Cortina Systems® LXT973 10/100 Mbps Dual-Port Fast Ethernet PHY Transceiver

Specification Update

20 March 2007

Revision 10.0

Figure 1 Example of Top Marking Information Labeled as Cortina Systems, Inc.

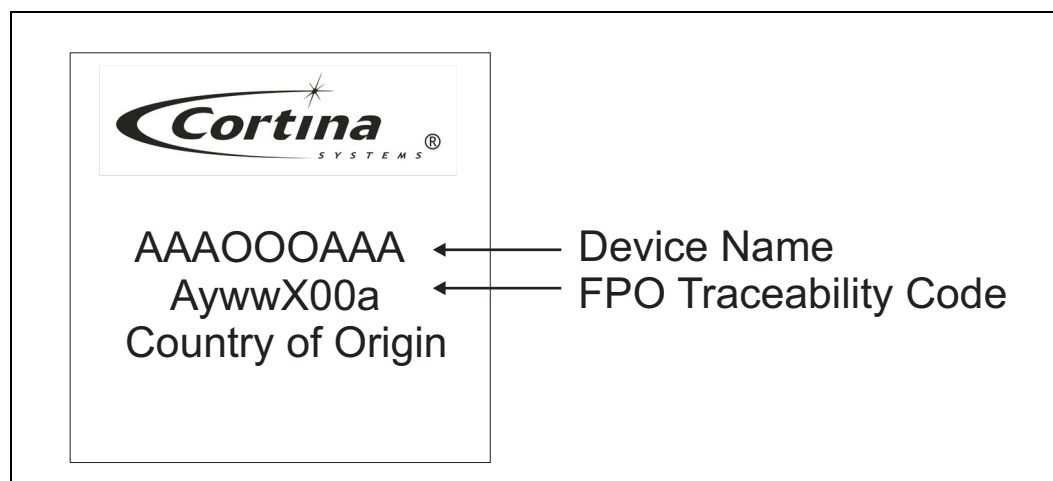
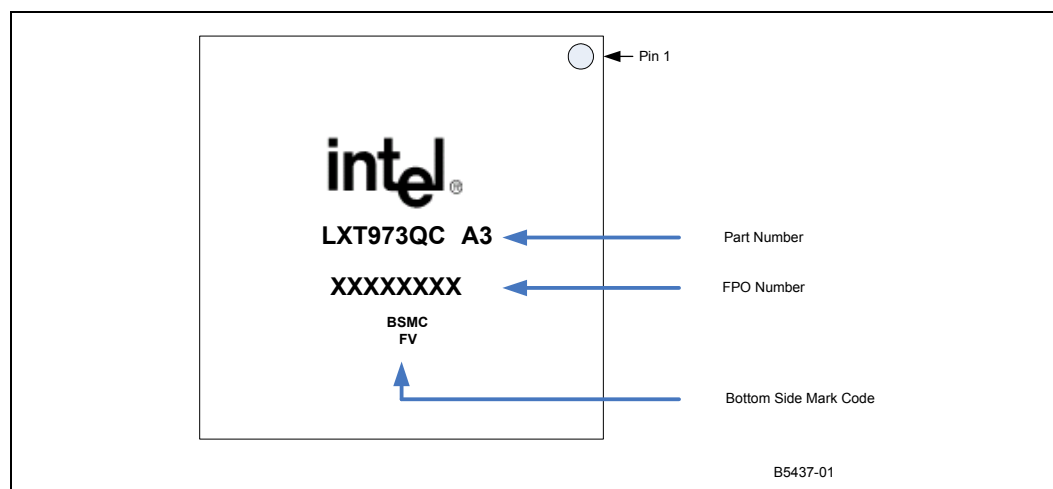
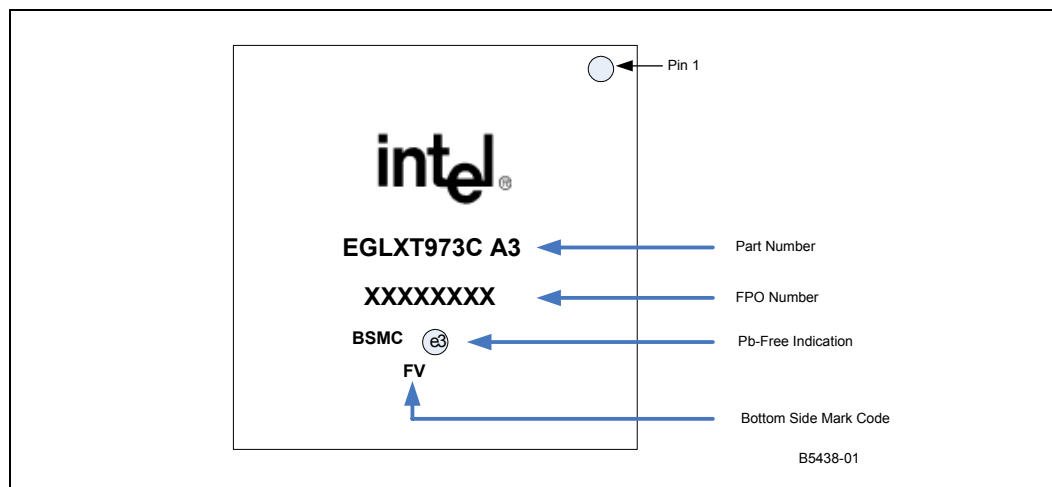
Figure 2 shows a sample PQFP package for the LXT973 PHY Transceiver.

1. In contrast to the Pb-Free (RoHS-compliant) PQFP package, the non-RoHS-compliant packages do not have the “e3” symbol in the last line of the package label.
2. Further information regarding RoHS and lead-free components can be obtained from your local Cortina representative.

Figure 3 shows a sample Pb-free RoHS-compliant PQFP package for the LXT973 PHY Transceiver.

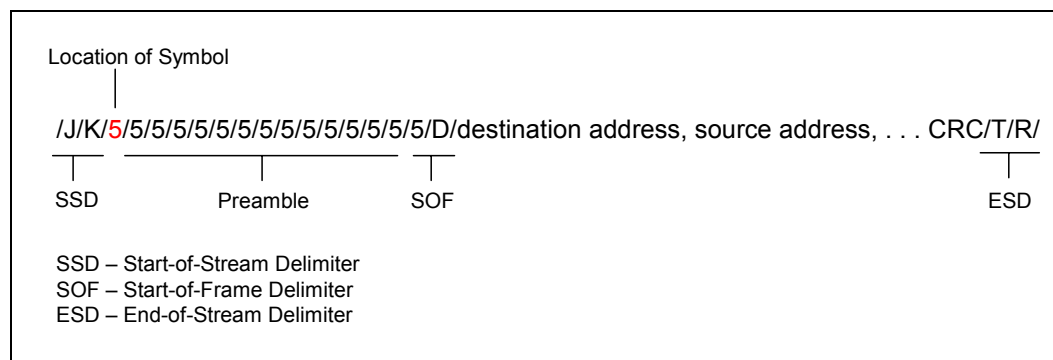
Item 9: Detection of Illegal Symbols After SSD

- Problem** An illegal symbol placed immediately after the Start-of-Stream Delimiter (SSD) (preamble after JK) is not detected. However, any subsequent corrupt symbol will be detected.

- Implication** RXER will not assert if this symbol location is corrupted. However, an error in this location does not affect packet integrity.
- Workaround** Use the MAC layer protocol to detect corrupt symbols in the packet.
- Status** There are no plans to fix this erratum.

Figure 4 **Ordering Information – Sample**

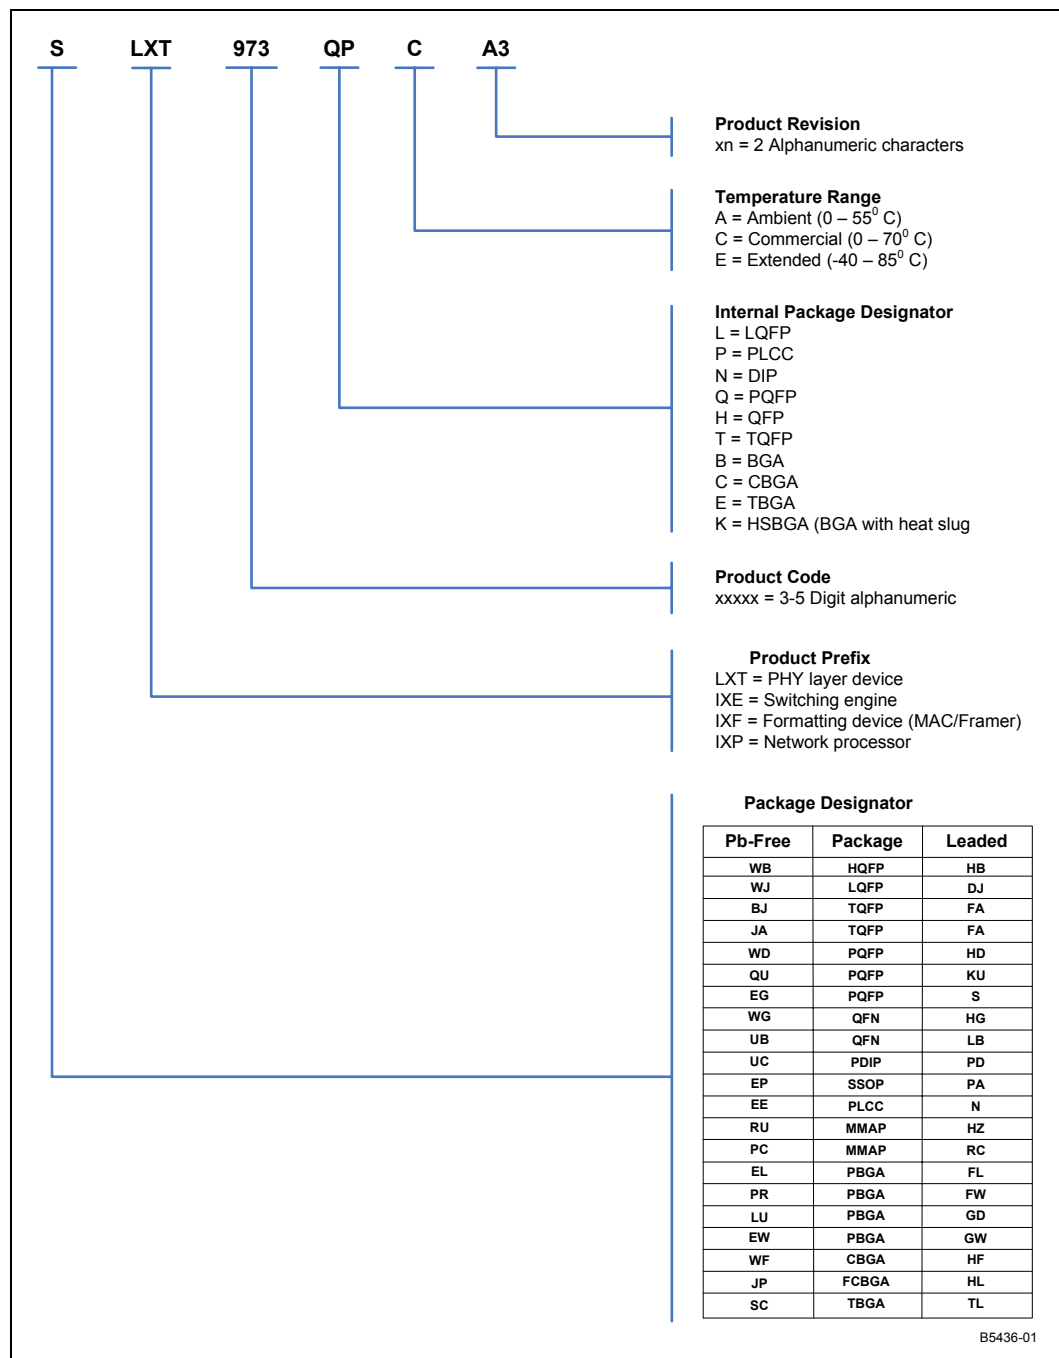
Item 1: Product Ordering Information

Table 3 lists the LXT973 PHY Transceiver product ordering information. Figure 4 provides the ordering information matrix.
